## Proposed nuclear power station Sizewell C

## **Proposed nuclear power station Sizewell C**

Please, find enclosed comments from the public including NGOs and authorities and an expert statement commissioned by the Federal Ministry for Climate Change for further consideration pursuant to Art. 6 of the Espoo Convention.

Figure 1:  
Land projected to be below annual flood level in 2050 around Sizewell C site.

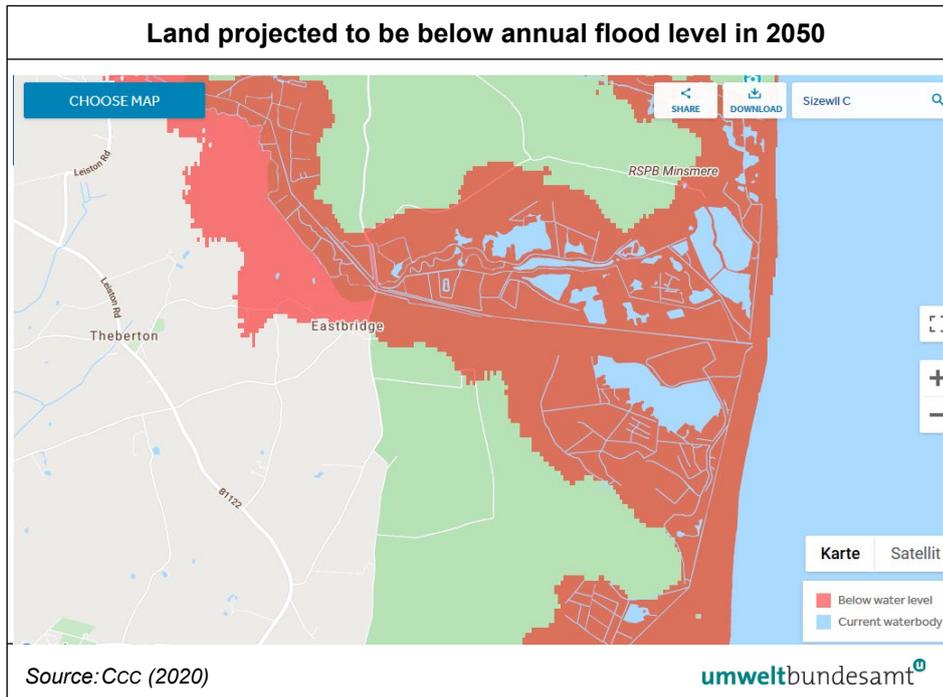
The Sizewell C site is prone to flooding events. This is illustrated by the following pictures, created by the Coastal Risk Screening Tool, which illustrates the land projected to be below the annual flood level in 2050. The Climate central sea-level maps are based on peer-reviewed science in leading journals. Improved elevation data indicate far greater global threats from sea level rise and coastal flooding than previously assumed. (CCC 2020)

Site-specific factors (in particular possible danger of flooding, climate change effects) could endanger Sizewell C. Flooding can be catastrophic consequences for a nuclear power plant. The EIA documents explain that a detailed assessment of site-specific nuclear safety and security risks would be undertaken as part of the nuclear site licensing regime. The authorities accepted that with this regulatory process in place regarding the safety of the UK EPR™ reactors and the EIA does not need to present a detailed assessment of nuclear safety risks.

Figure 2:  
 Deposition of Cs-137  
 after a severe accident  
 at the Sizewell site,  
 weather situation of 10  
 Jan 1995.

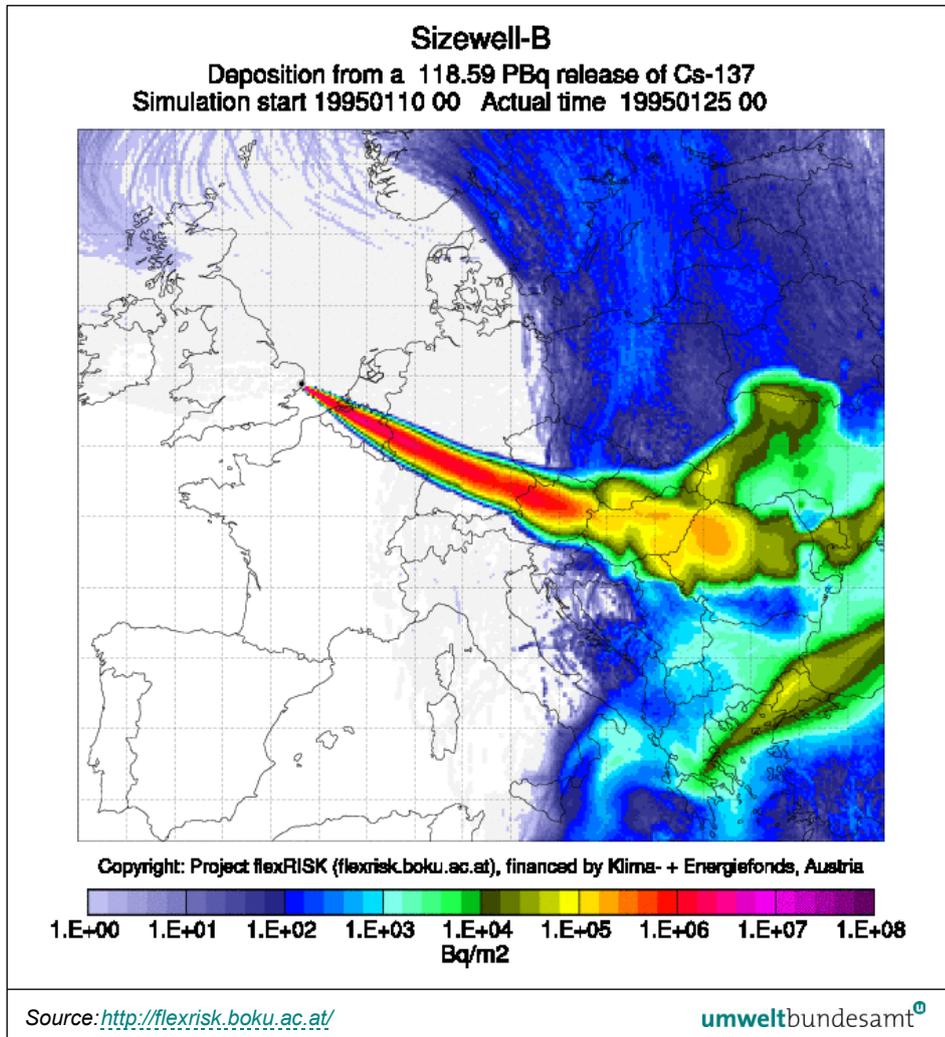
Under weather conditions similar to those on 10 Jan 1995, large parts of the territory of Austria would be significantly affected by an accident at the Sizewell site. Contaminations in Austria could reach up to a few 100 kBq Cs-137/m<sup>2</sup> (orange and red scale, up to 1E+06 Bq/m<sup>2</sup> = 1,000 kBq/m<sup>2</sup>).

Areas with such contamination are considered contaminated according to IAEA classification, since the population in these areas can expect an effective dose of more than 1 mSv in the first year (LELIEVELD et al. 2012).

Contaminations of several 100 kBq Cs-137/m<sup>2</sup> like in figure 2 or 3 are much higher than these levels, therefore agricultural countermeasures could be necessary on Austrian territory in case of a severe accident at the Sizewell site; Austria would be severely affected.

Figure 3:  
 Deposition of Cs-137  
 after a severe accident  
 at the Sizewell site,  
 weather situation of 6  
 Nov 1995.

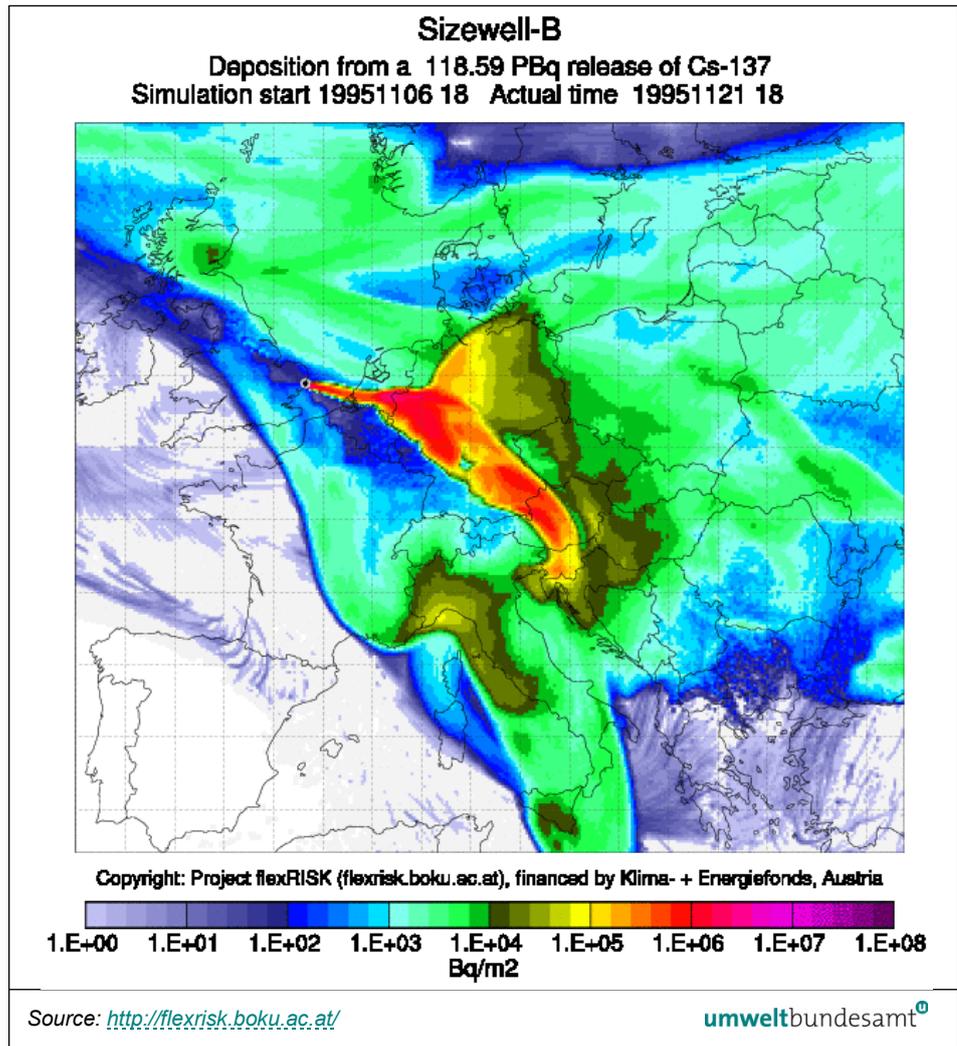
A considerable contamination of the Austrian territory would result from a potential Caesium-137 release of 118.59 PBq at the Sizewell NPP site under conditions comparable to those on 6 November 1995. Almost all regions in Austria would receive depositions of more than 1,000 Bq/m<sup>2</sup> (1E+03 Bq/m<sup>2</sup>). In large areas the values could be above 1E+05 Bq/m<sup>2</sup>, even up to 1E+06 Bq/m<sup>2</sup>.

Figure 4:  
 Integrated concentration of I-131 from a severe accident at the Sizewell site, weather situation of 6 Nov 1995.

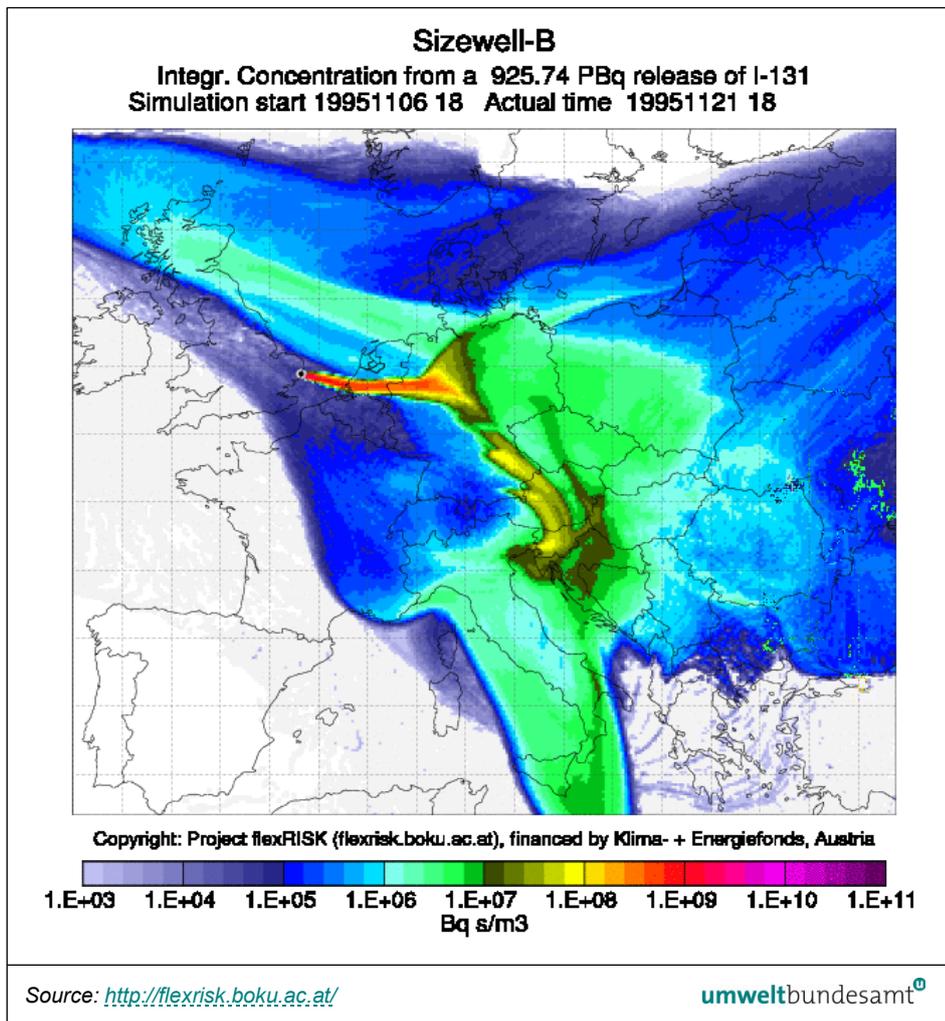
Also a contamination with Iodine-131 can lead to significant impacts on Austrian territory, as is shown in figure 4.

Figure 4 shows a meteorological scenario for I-131. The highest concentration on Austrian territory can be up to several 1,000 Bq h/m<sup>3</sup>. Also this concentration is far above the above mentioned level which requires the start of agricultural countermeasures in Austria.

Figure 5:  
Possible thyroid dose for infants for a weather situation like on 6 June 1995; maximum dose for 7 days in Austria is 25.67 mSv.

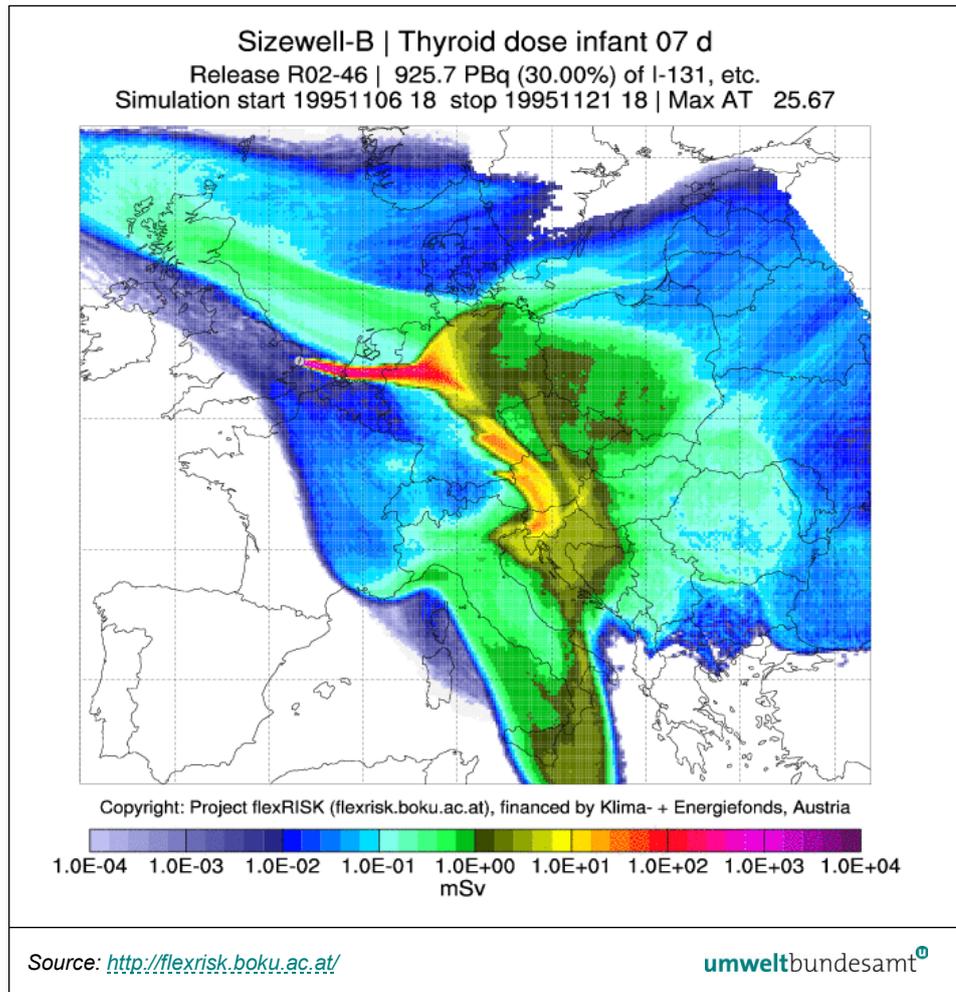
Figure 5 shows the maximum thyroid dose for infants resulting from an I-131 release in a weather situation like on 6 June 1995. Up to 25.67 mSv could be expected in 7 days. This could result in the intervention measure of iodine prophylaxis for risk groups.

Figure 6:  
 Weather-related probability for a deposition of >185 kBq Cs-137/m<sup>2</sup> due to a severe accident at the Sizewell site.

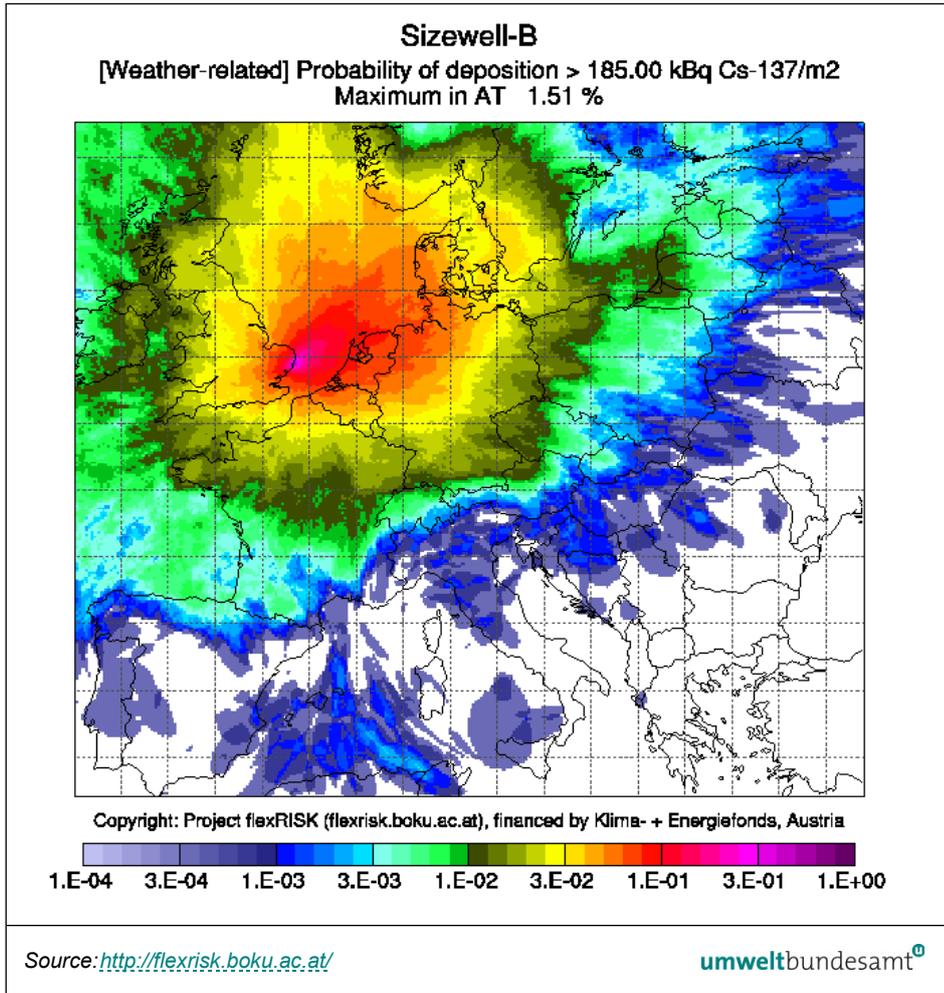
When summarizing the weather-related probability of Austria being contaminated with more than 150 kBq Cs-137/m<sup>2</sup> by a severe accident in Sizewell, a maximum probability of 1.51% is calculated (see figure 6). Such a contamination would be comparable to the highest contaminations that occurred in Austria after Chernobyl (186 kBq Cs-137/m<sup>2</sup>).
